TENTATIVE AGENDA
AUGUST 13, 2025 6:00 P.M.
ARCHITECTURAL REVIEW BOARD

MINUTES
ARCHITECTURAL REVIEW BOARD MEETING
July 9, 2025 – 6:03 p.m.

REVIEW OF PLANS FOR ATTACHED COVERED PORCH ADDITION AND DETACHED CARPORT AND STORAGE SHED – Patrick Holleran, 112 Elm Ave.

A 1.4

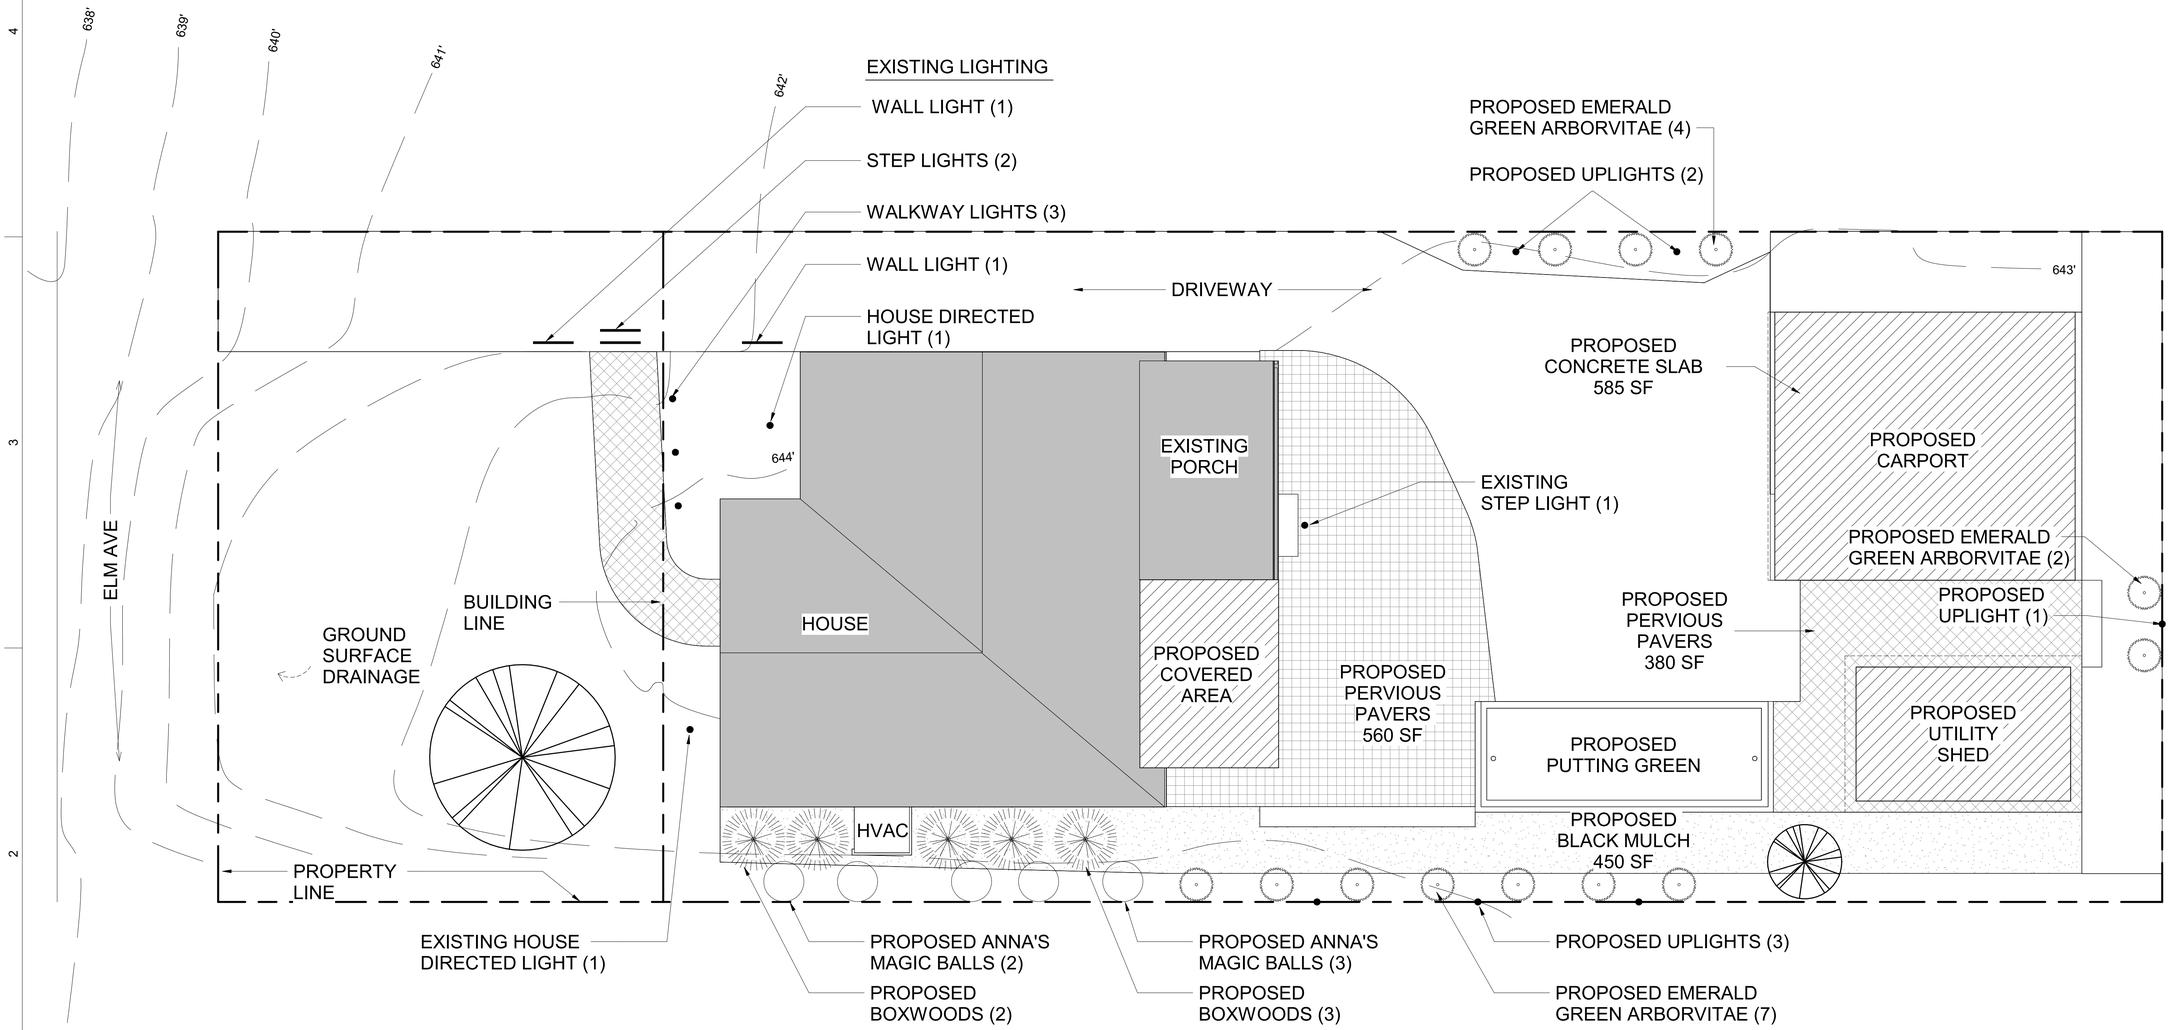
Mr. Holleran explained that he's using permeable pavement. Mr. Falk and Mr. Moran noted that the permeable pavement needs to be clearly labeled on drawings. They also noted that contours should be included on page A1.4, and expressed that the plans would benefit from having the spot elevations noted at the corners of the pavements, so they can

Mr. Falk noted that there's a French drain shown on page A1.4. He's assuming that the drainage plan on page A1.4, there's a French drain shown. He said he's assuming this is for the pervious paver area, but he noticed that there's not a French drain located on other pervious paver areas. Mr. Falk recommends adding that to the other pervious pavement areas.

Landscaping
Mr. Moran noted that the plans show that there are plantings on the property line and instructed that these should be moved off the line and into the subject property's yard. The applicant said that this was an error in the drawings and that it would be updated.

Mr. Moran noted that the drawings show the driveway abutting the property line to the north and trees being planted on the property line. The ARB stressed that trees should not be planted on the property line and requested that the revisions accurately show the landscaping. If the applicant decides to use tree grates, they need to show them on the drawings.
